# C17-49018-00

## 46640 FIRMWARE

### UPGRADE KIT

- Document Eprom upgrade to achieve Y2K compliance.

FIG. 1 - 46020 MAP EPROM LOCATION

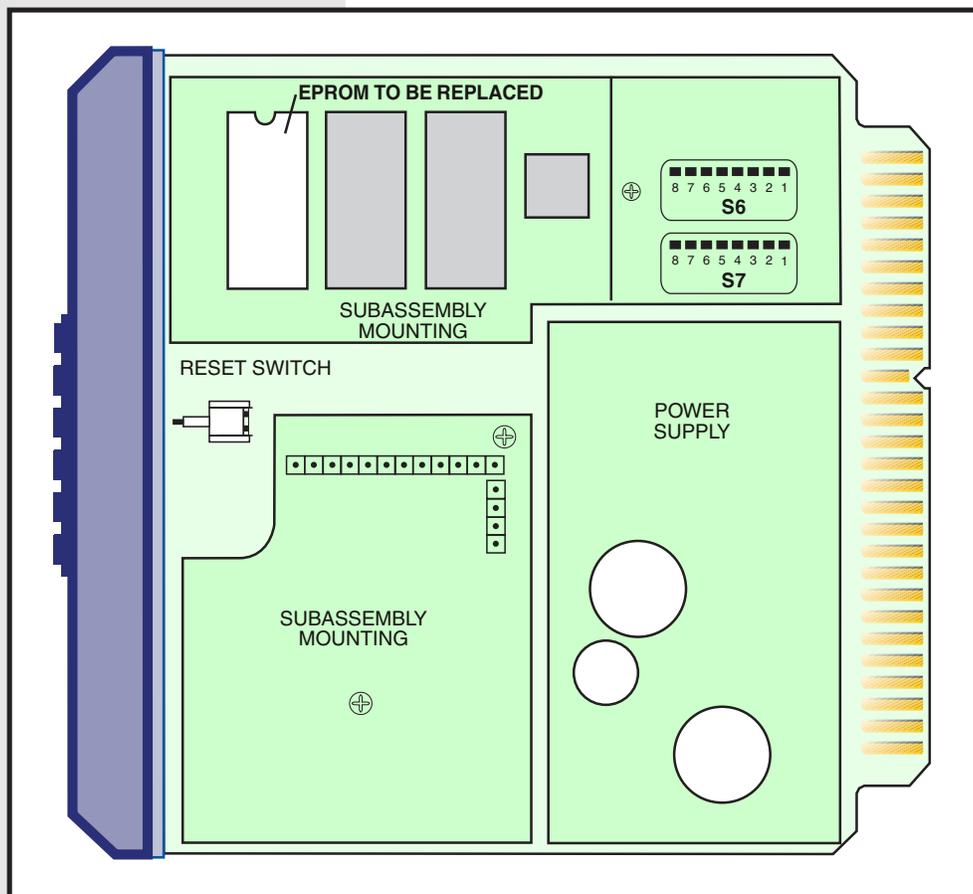
2. Remove the module to be upgraded and place the module on an ESD approved work area. The component side should be up and the blue handle to the left.
3. The EPROM to be removed is located in the top left corner of the module (Refer to Fig. 1) and is labeled C82-00308-00. (Older units may be labeled A82 or B82.) Before removing this chip, note its orientation. (The notch is toward the top of the module.)
4. Remove the old EPROM by pulling straight up on the IC. It may be necessary to use a small screwdriver to gently pry the old EPROM up.
5. Set the old IC to the side.
6. Continue to step 2, but remain aware that after completing the upgrade, the database must be downloaded from the T/Shell program into the MAP.

1. Install the replacement EPROM, labeled E82-00308-00, in the socket. Verify that the orientation is the same as the old EPROM.
2. Applying even pressure, push the IC into position. Exercise caution not to bend any pins on the IC.

1. On the firmware subassembly, just below the EPROM, is a label. If that label is marked A, B, or C17-46640-01, replace it with the new label D17-46640-01.
2. If there is an identification label at the bottom of the front panel marked C11-46020-40, replace it with the label marked D11-46020-40.
3. Remove the bar code label from the front of the blue handle and replace it with the new label that is marked RMPQADB7AA.
